Economic Commission for Europe**Inland Transport Committee****World Forum for Harmonization of Vehicle Regulations****Working Party on Passive Safety****Fifty-seventh session**

Geneva, 18-22 May 2015

Proposal for a new Regulation on Frontal Impact**Draft new 01 series of amendments to the draft new Regulation on uniform provisions for the approval of passenger cars in the event of a frontal collision with focus on the restraint system****Submitted by the expert from France as Chair of the Informal Working Group on Frontal Impact ***

Model A

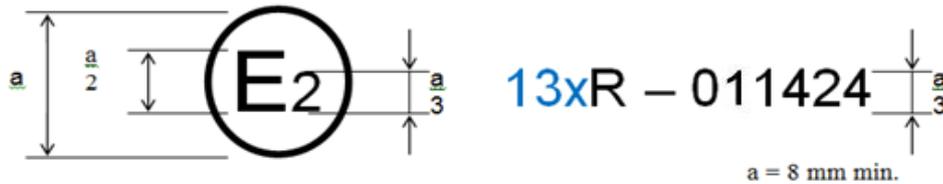
The above approval mark affixed to a vehicle shows that the vehicle type concerned has, with regard to the protection of the occupants in the event of a frontal collision, been approved in ~~the Netherlands (E 4)~~ **France (E2)** pursuant to Regulation No. ~~{13X}~~ under approval number ~~021424~~ **001424**. The approval number indicates that the approval was granted in accordance with the requirements of Regulation No. ~~{13X}~~ ~~as amended by the~~ **021** series of amendments.

Model B

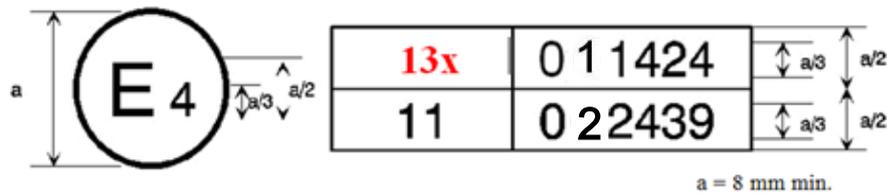
The above approval mark affixed to a vehicle shows that the vehicle type concerned has been approved in the Netherlands (E 4) pursuant to Regulations Nos. [13X] and 11.¹ The first two digits of the approval numbers indicate that, at the dates when the respective approvals were granted, Regulation No. [13X] incorporated the ~~02~~ **01** series of amendments and Regulation No. 11 incorporated the 02 series of amendments."
